Viking Subscriber Software 21.1.1 Maintenance Release

Effective Release: May 23, 2022

FSN-0522-VIKING-22

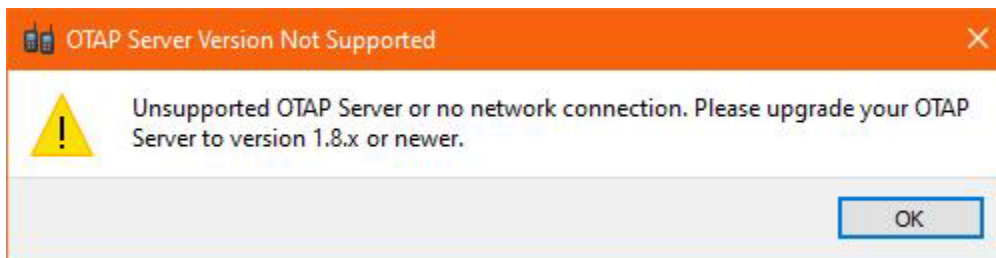
Armada users connecting to OTAP Server will receive the below error notification as of May 20, 2022, and will be unable to perform OTAP operations. The OTAP Connection Test will also fail.

Please upgrade OTAP Server and Armada to the versions listed in this notice or later to resolve this issue.
